memorandum

Re: Foundation Investigation Report for
Little Garden River Crossing #2
Hwy. #556, District #18, Sault Ste. Marie
W. P. 277-85-02

Little Garden River Bridge # 2 - Hwy. 556

Site No: 38S-21 W.P. 277-85-02

FOOTING LAYOUT & REINFORCING

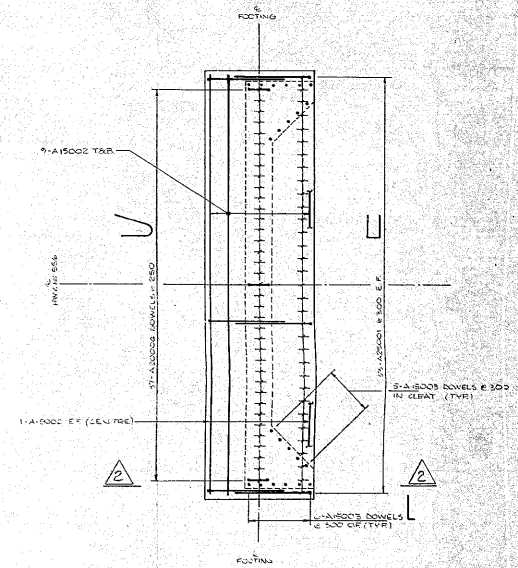
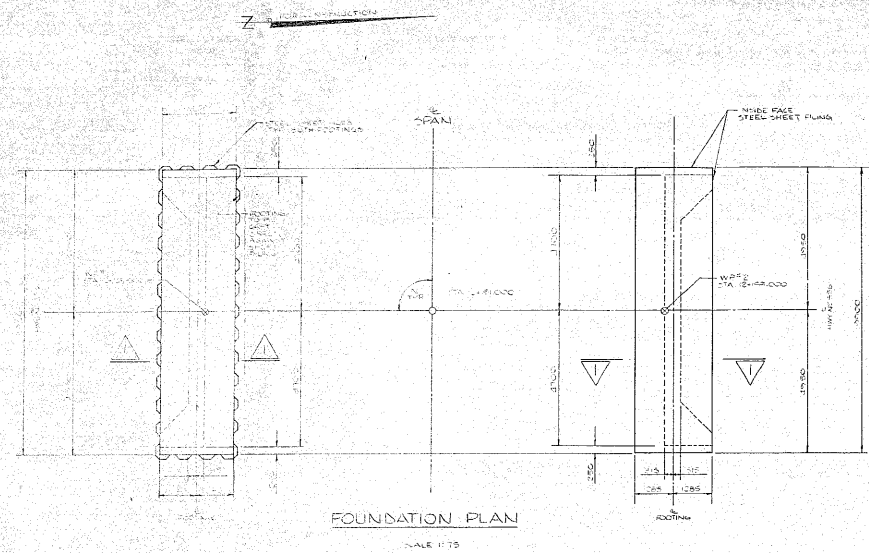
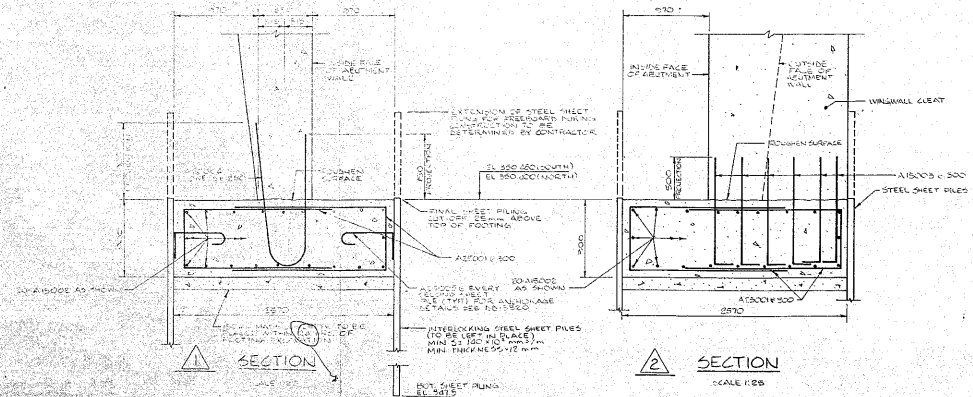
We have reviewed the final Drawing 1 and Drawing 3 (dated Sept.86) for the above-noted structure. We have the following comments:

1. In view of the well-graded nature of the natural soils at the site, we feel that a geotextile is not required below the rock protection. Furthermore, if a geotextile is used, its placement will be difficult to control underwater.
2. In areas where fill is required, peat and other surficial organic material should be completely subexcavated to at least 1 m beyond the plan limits of the embankment. All fill placed below 0.3 m above the prevailing groundwater level should consist of granular material.
3. In view of the presence of occasional boulders across the site, the sheet piles, as indicated on the drawings, may get 'hung-up' and may not be able to advance to the required tip elevation.

The contractor should be informed through a Special Provision of the occasional cobbles and possible boulders which exist across the site. The contractor should be required to submit a dewatering scheme for M.T.C. approval. In addition, the S.P. should include a provision indicating that if sheet piles are used in the scheme, they should be left permanently in place.
